Access Compliance Report

Public Rights-of-Way

(Curb Ramps)

Intersection ID: 14355	Main Street: OAKMONT_AV	Cross Street: PINECREST_AV	Location: SE
ADA ID: 31A808408ECD	Ramp Type: Perp	Initial Pass/Fail: Fail	Overall Compliance: No
		Severity Score: 22.5

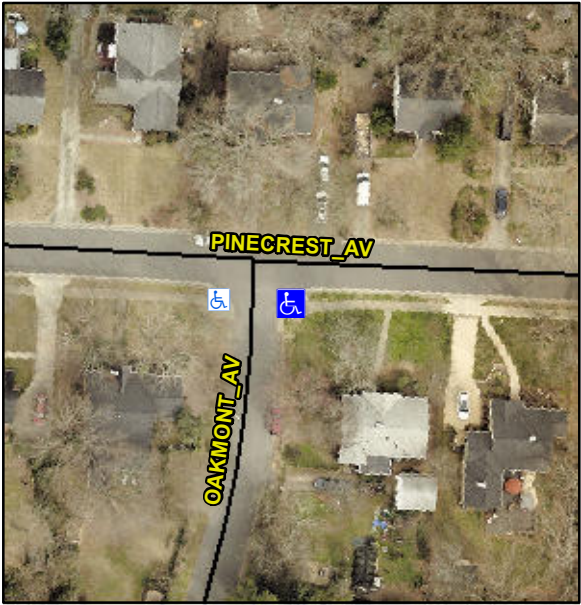
Codes/Mitigation Info/Possible Solution			Field Measurements/Component Compliance		
	Possible Solutions:		Compliance	Description	Data
	Remove & Replace Entire Ramp.		No	Ramp Length (in)	44.0
			No	Ramp Width (in)	43.0
			N/A	Flare Type LT	N/A
			N/A	Flare Slope LT (%)	N/A
			N/A	Flare Traversable LT?	N/A
			N/A	Landing Length (in)	N/A
			N/A	Landing Width (in)	N/A
			N/A	Landing Slope (%)	N/A
			N/A	Landing X Slope (%)	N/A
<p>Surveyor Notes:</p> <p>N/A</p> <p>PROW/ADA:</p> <p>Not Found, R304.5.1, R304.2.2, R304.5.3</p>			N/A	Flare Type RT	N/A
			N/A	Flare Slope RT (%)	N/A
			N/A	Flare Traversable RT?	N/A
			N/A	DWS Provided?	N/A
			N/A	DWS Contrast?	N/A
			N/A	DWS Length (in)	N/A
			N/A	DWS Full Width?	N/A
			N/A	DWS Offset (in)	N/A
			N/A	Gutter Ponding?	N/A
			N/A	Gutter Lip Ht (in)	N/A
<p>Total Cost:</p> <p>\$ 1850.00</p>			No	Painted X Walk1?	N/A
			To W	X Walk 1 Direction	N/A
			N/A	X Walk 1 Width (in)	N/A

1.0	X Walk 1 Slope (%)	N/A
			2.8	X Walk 1 X Slope (%)	N/A
			N/A	Ramp inside XWalk1?	N/A
			N/A	Road Slope (%)	N/A
			N/A	Road X Slope (%)	N/A
			N/A	Any Obstructions?	N/A
			N/A	Obstruction Type	N/A
			N/A	Clear Space?	N/A
			N/A	Clear Space to XWalk (in)	N/A
			N/A	Storm Grate/Utility Hazard?	N/A
			N/A	Storm Grate/Utility Type	N/A
			Yes	Surface Condition? (G/P)	Good
